Access Compliance Report

Public Rights-of-Way

(Curb Ramps)

Intersection ID: 50998	Main Street: S_TRYON_ST	Cross Street: STEELECROFT_PY	Location: SE
ADA ID: E1A3C46FB7BE	Ramp Type: Perp	Initial Pass/Fail: Fail	Overall Compliance: No
Severity Score: 12.5			
Codes/Mitigation Info/Possible Solution		Field Measurements/Component Compliance

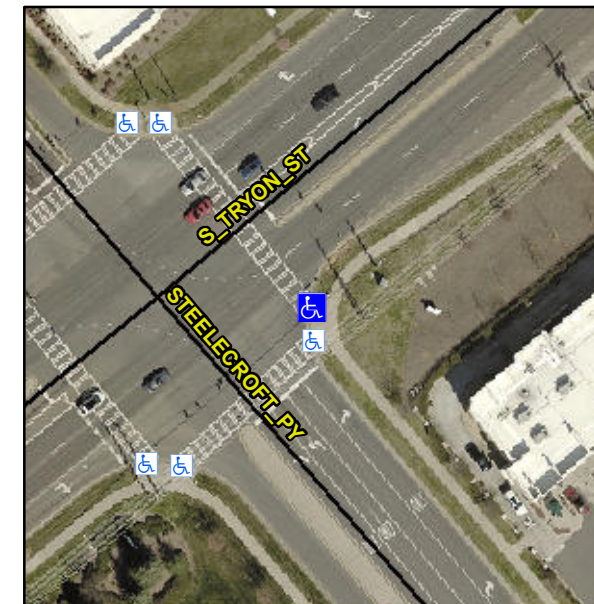
Not Found, R304.5.3

Compliance	Description	Data	Compliance	Description	Data
N/A	Ramp Length (in)	96.0	Yes	Ramp Slope (%)	6.8
Yes	Ramp Width (in)	48.0	No	Ramp XSlope (%)	6.6
N/A	Flare Type LT	N/A	N/A	Flare Type RT	N/A
N/A	Flare Slope LT (%)	N/A	N/A	Flare Slope RT (%)	N/A
N/A	Flare Traversable LT?	N/A	N/A	Flare Traversable RT?	N/A
N/A	Landing Length (in)	N/A	N/A	DWS Provided?	N/A
N/A	Landing Width (in)	N/A	N/A	DWS Contrast?	N/A
N/A	Landing Slope (%)	N/A	N/A	DWS Length (in)	N/A
N/A	Landing X Slope (%)	N/A	N/A	DWS Full Width?	N/A
N/A	Landing Curb? (Y/N)	N/A	N/A	DWS Offset (in)	N/A
N/A	Shared Landing?	N/A			
N/A	Gutter Ponding?	N/A	N/A	Gutter Slope (%)	N/A
N/A	Gutter Lip Ht (in)	N/A	N/A	Gutter X Slope (%)	N/A
N/A	Painted X Walk1?	Yes	N/A	Painted X Walk2?	N/A
	X Walk 1 Direction	To NW		X Walk 2 Direction	N/A
N/A	X Walk 1 Width (in)	111.0	N/A	X Walk 2 Width (in)	N/A
	X Walk 1 Slope (%)	8.4		X Walk 2 Slope (%)	N/A
	X Walk 1 X Slope (%)	1.7		X Walk 2 X Slope (%)	N/A

Remove & Replace Entire Ramp.
